\*\*\*\*\*FIELD CHANGE ORDER\*\*\*\*\*

LOCATION: Lot 9, Magnolia Crest

PLANS REF: 15-2-2252 by Murphy Garrow Design Group, inc.

Application # 07-50017514  
Dail Builders 279 Curragh Cove  
Lot 9 Magnolia Crest

Page: 3 of 3

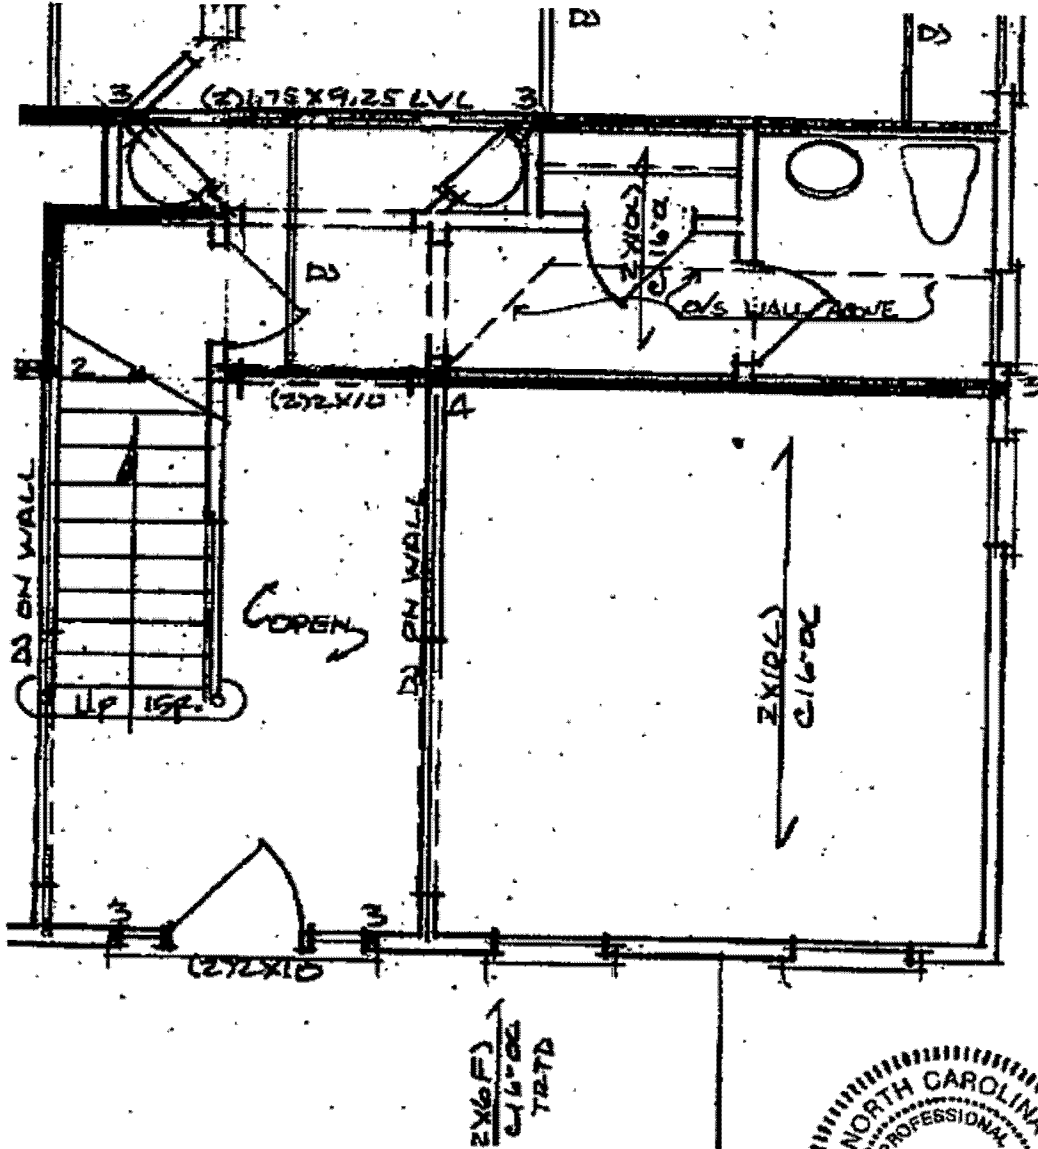
**Second Floor Ceiling Framing:** Plans specify a continuous (2)1.75x9.25 LVL beam running left to right across the open foyer and master bedroom ceiling at the 8'-0" ceiling height with intermediate bearing reinforcement at the left master bedroom wall per detail "A" on sheet 6 of 7. Per the builder, the portion of (2)1.75x9.25 LVL running across the bedroom was raised to the 9'-0" ceiling height to allow for framing of the tray ceiling per architectural plans. Refer to pages two and three of this letter for framing.

**Response:** Be advised that the above described ceiling framing is structurally acceptable and the bearing reinforcement not required due to new loading conditions.
